Appln No. 09/991,199

Amdt date February 27, 2004

Reply to Office action of December 1, 2003

REMARKS/ARGUMENTS

FIG. 2A

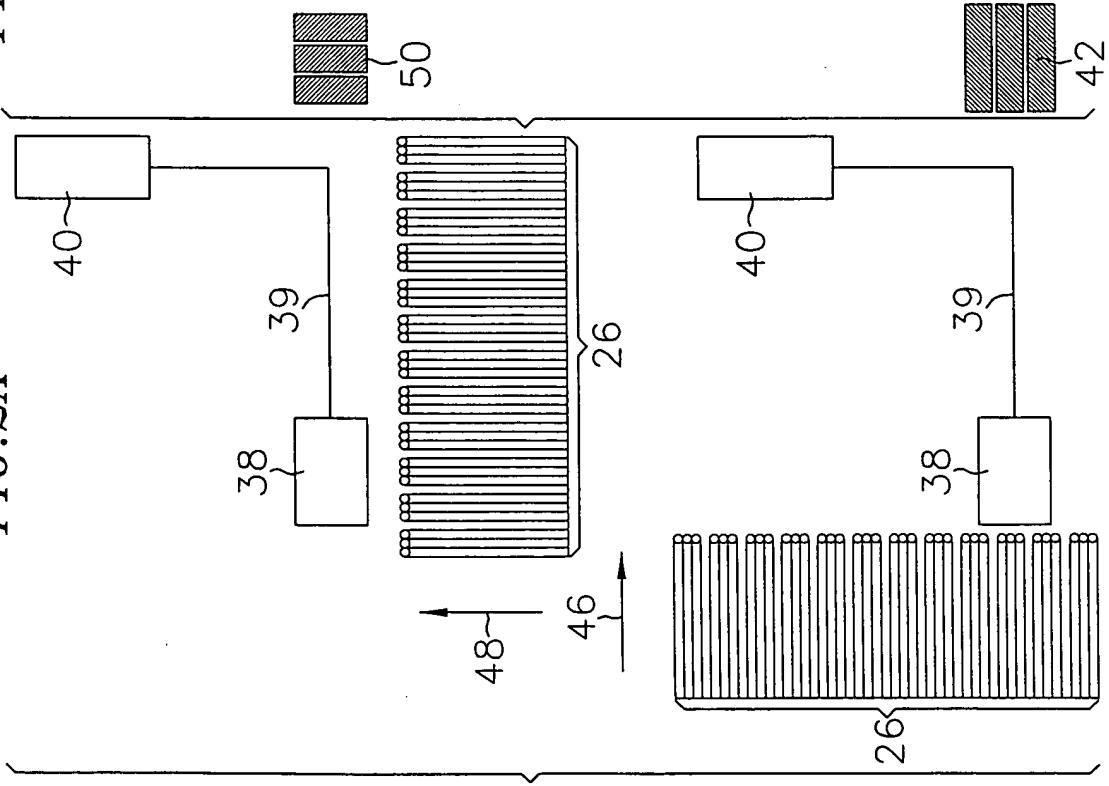
The drawings have been objected to as not showing every feature of the invention specified in the claims. The objected to claim limitations have been canceled. Figures 1-3 have been objected to as requiring a "Prior Art" legend. Enclosed please find Figures 1-3 showing the requested legend in red ink for the Examiner's approval.

PRIOR ART
